DOE/ID-11066
Revision 0
Project No. 23339
June 2003

Monitored Natural Attenuation Operations, Monitoring, and Maintenance Plan for Test Area North, Operable Unit 1-07B

Agency Comments and Resolutions for the Draft Version of the Monitored Natural Attenuation Operations, Monitoring, and Maintenance Plan

Figure 3-1. Document hierarchy for the monitored-natural attenuation component of the Operable Unit 1-07B remedy.

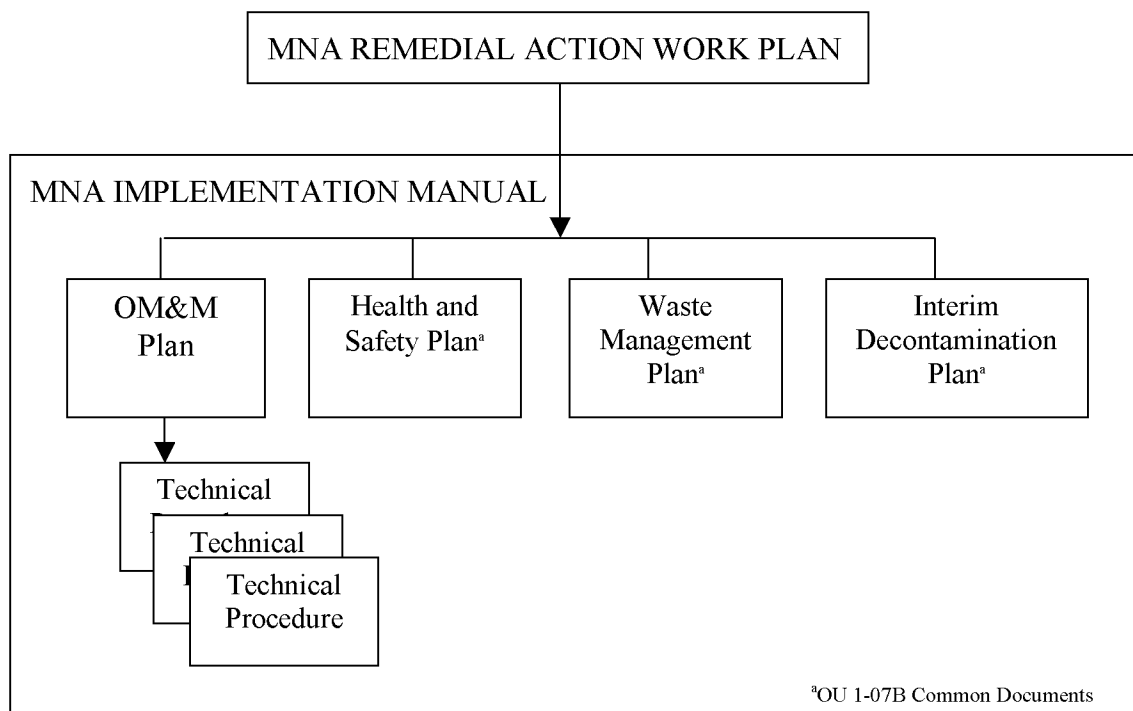
| Item No. | Page No./ Section/Zone | Review Comment | Comment Resolution |
|----------|--|---|---|
| 3 | Page 3-2 Section 3.1, Figure 3-1 | <p>The text describing the decision point between “Performance Operations” and “Balance of Remedy” requires some editing. It is premature after only 2 years of “Initial Operations” and 5 years of “Performance Operations” to conclude that “identification of a mechanism for natural degradation of TCE eliminates the need for a contingency remedy, shortens the performance operations period, and initiates long-term operations.”</p> <p>Data from the distal zone are not conclusive even with the identification of a mechanism for natural degradation and the extension of the operational period. It is probable that at least one-half for TCE will be needed to confidently predict the appropriate time to enter “long-term operations” after we have a mechanism identified which will quantify the half-life).</p> <p>Also, the ability to shelve the contingency remedy will not be possible until more than one-half for TCE has expired in order to assure the agencies that MNA is functioning as expected in the predicted time frame. Considering the low concentrations associated with the distal zone, it is possible that two half-lives will be needed to confidently draw the conclusions noted in this text. At this time, the first-order degradation rate for TCE appears to be on the order of 13 years (Monitored Natural Attenuation Remedial Action Work Plan for Test Area North Final Groundwater Remediation, Operable Unit 1-07B (Draft), Table 4-2, Page 4-14). The agencies need to discuss the time frames portrayed in this figure and discuss the relationship of these time frames to the probable half-life of TCE in the distal zone.</p> | <p>Per the strategy developed at the face-to-face meeting, the monitoring plan will be revised to include only performance operations, with annual sampling in Zones 1 and 2, through 2013 and longer if needed, as determined by the Agencies in the RA Report.</p> |

Figure 4-1. Monitoring wells identified for the monitored-natural-attenuation component of the Operable Unit 1-07B remedy.

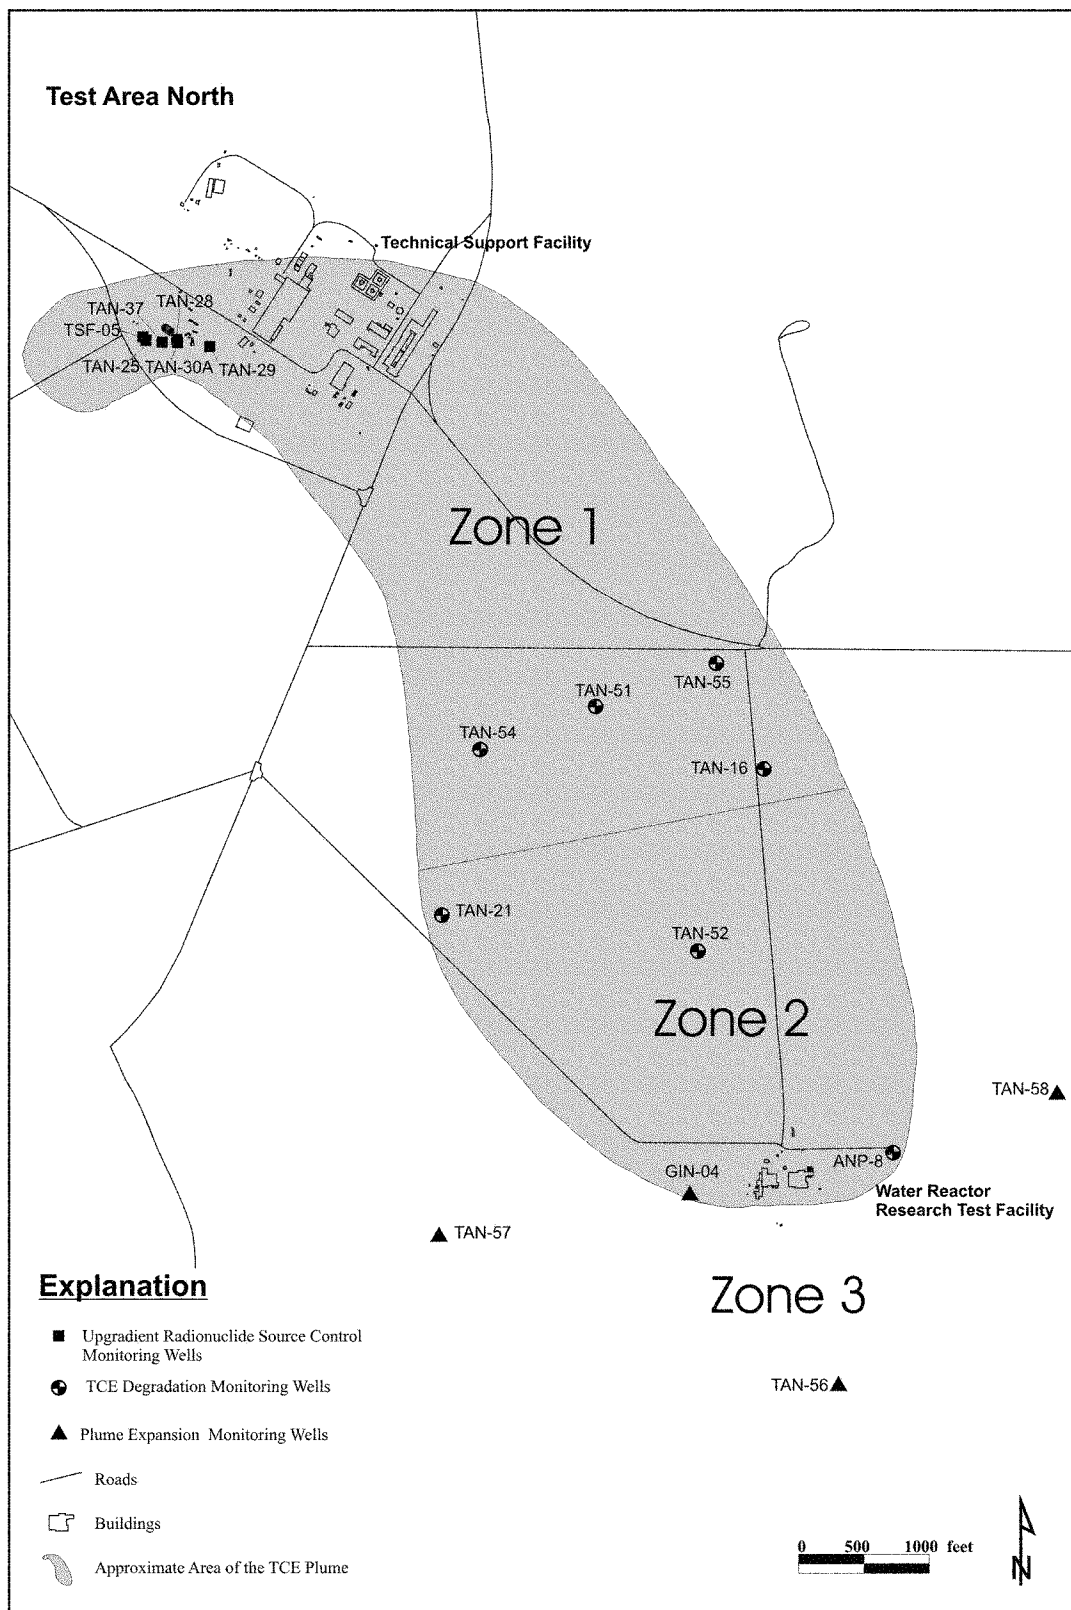
| Item No. | Page No./ Section/Zone | Review Comment | Comment Resolution |
|----------|---|---|---|
| 5 | Page 4-1 Section 4, Figure 4-1 | <p>There have been discussions centered on replacing monitoring well TAN-48. This is a critical function since we are assuming TAN-51 and TAN-52 represent the suspected axis of the plume. Adequate monitoring of the axis of the plume is critical to our ability to determine risk and whether the RAOs will be met. The proposed distal MNA monitoring network currently appears inadequate to derive the necessary data to make these determinations.</p> <p>As the plan exists, the most contaminated 3,000 ft of the aquifer in the distal zone will not be monitored. Historical concentrations in TAN-48 are 2 to 3 times those in TAN-51. Therefore, this is the portion of the distal zone where evaluation of degradation rates is most important, as it will drive our RAO evaluations.</p> <p>It is approximately 2,600 ft from TAN-48 to TAN-51, at .35 ft/day (RAWP 2003); this is approximately 20 years travel time. It would take approximately 10 years for clean water from the NPTF injection well to affect a monitoring well constructed half way between the wells (i.e., 1,300 ft). Further, the identification of clean water in a well upgradient from TAN-51 would have several beneficial impacts regarding the effectiveness of the NPTF and on our assumptions concerning the axis of the plume and dispersion of contaminants.</p> | <p>As discussed at the Agency face-to-face, the recommended monitoring network will provide adequate coverage to verify the progress of the remedy. While it is true that there is no well between TAN-48 and -51, there is not a specific need for data in that area. Based on the widespread characterization of the plume as the last 7 years of monitoring, we have a reasonably good understanding of how the plume will behave in that area. TAN-51 will exhibit post-breakthrough degradation behavior soon. Having an upgradient observation point in what is now a higher concentration area may be interesting. It may also be of interest to see NPTF breakthrough water earlier. These possibilities, however, probably would not justify the cost of installing a new well, particularly when its utility would decrease substantially after about 10 years (1/10 of the remedy period).</p> <p>Please note that the 0.35 ft/day is a conservative average and the reinjection of NPTF water will significantly affect the water velocity that area.</p> |

| Item No. | Page No./ Section/Zone | Review Comment | Comment Resolution |
|----------|--|--|---|
| 13 | Page 5-13 Section 5.3.2.5 | <p>There are several sentry wells near the 5µg/l isopleth in Figure 4-1, (MW-2, TAN-24A, GIN-02 and GIN-03), which indicate the plume has not expanded beyond these wells. We need a starting point and it appears to be significantly up gradient from TAN-56. Currently TAN-56 is approximately 1,370 ft down gradient from this line. In a 9,000-foot plume, this is about a 15% expansion to TAN-56. It appears that while monitoring of TAN-56 is important, so is monitoring of MW-2, TAN-24A, and either GIN-02 or GIN-03.</p> <p>The use of a 5-year period of concentration exceedance of the 5µg/l criteria to justify construction of an additional down gradient monitoring well may be acceptable. However, we need to establish a mechanism in this document to ensure that in the future, if we get an exceedance, sampling is performed on an annual basis for an adequate number of years to verify this exceedance.</p> <p>The last sentence of this paragraph needs to be more specific as to what is meant by “consistently exceed 5 µg/L (as measured over a 5-year period)....” Please specify an appropriate test and confidence level for making this determination.</p> | <p>It is our recommendation that sub-section 5.3 be removed from the OMMP as it is duplicative of a nearly identical section in the RAWP. Doing so will focus the OMMP on the operational aspects of maintaining and operating the monitoring network.</p> <p>In response to the comment, however, the monitoring plan will be revised to include GIN-4 as well as TAN-56, 57, 58 in Zone 3 (per the discussion at the Agency face-to-face). In addition, should concentrations at GIN-4 exceed 10 ug/L, the sampling frequency will be increased to annual. The DQOs and decision rules will be revised in the RAWP to clarify how the data will be used for each decision. For example, simple detections > 10 ppb at GIN-4 or TAN-56, would trigger modifications to the monitoring plan. A formal hypothesis test, as suggested in the comment, would be appropriate for the final decision to declare MNA non-functional in Zone 3 due to plume expansion beyond the 30% point.</p> |
